**CAPITOL ZONING DISTRICT COMMISSION
STAFF REPORT
3/28/18
BIM / JBC**

Location: 1512 South Spring Street
Owner: Mizan Rahman & Elizabeth Barnett
Permit Type: Certificate of Appropriateness (*amended*)

Description: This request is for an amended Certificate of Appropriateness to approve completed work that was not contemplated in an application approved by the Commission in October 2016. The application that was approved in October 2016 called for:

Images of front façade

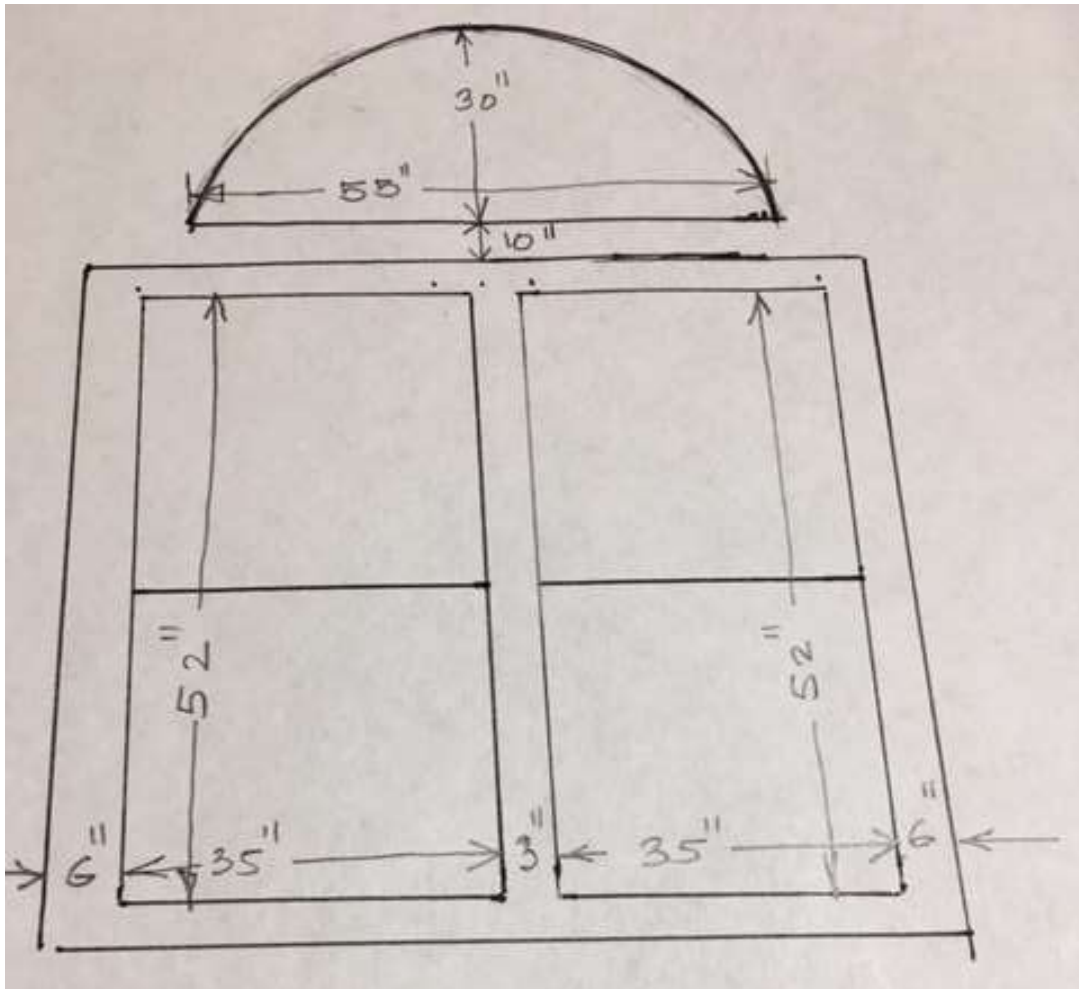
Staff believes the installed fanlight (semi-circular window) on the front façade and decorative trim around the attic vent are not consistent with this principle.

Staff believes the installed fanlight (semi-circular window) on the front façade is NOT consistent with these standards. The applicant's request for an after-the-fact review of this window constitutes a request for a waiver of these standards.

Staff finds the replacement windows that were installed are NOT consistent with this standard. Though the windows they replaced were not original, staff does not believe the replacement models resemble the appearance of traditional wood windows in their dimension, profile, or finish. The applicant's request for an after-the-fact review of these windows constitutes a request for a waiver of this standard.

Staff finds the decorative trim around the attic vent is NOT consistent with this standard. The applicant's request for an after-the-fact review of these windows constitutes a request for a waiver of this standard.

Staff finds the windows and decorative trim installed on the front façade are not consistent with these standards.

Still remaining though, are items 3, 4, and 5. Staff believes the proposal to replace the former metal windows with new windows resembling divided-light double-hung windows, like those seen traditionally in the neighborhood was an integral component of the approved work. Staff also believes the semi-circular windows installed above these is altogether different from the rectangular transom window that was approved for installation. Finally, staff believes that the reconfigured attic vent with decorative trim represents a substantial departure from the approved work, not consistent with the Standards.

Since a case of economic hardship is unlikely to be established here, and since the asterisked standards cannot otherwise be waived, staff must recommend **denial** of the request for one-over-one vinyl windows on the front façade, the semi-circular fanlight, and the repositioned attic vent with decorative trim.

Design Review Committee Recommendation: The applicants were not present. The Committee voted unanimously (9-0) to concur with staff's recommendation of **denial**. Several members also expressed that installing the 30x60" windows shown in the original application should be required.
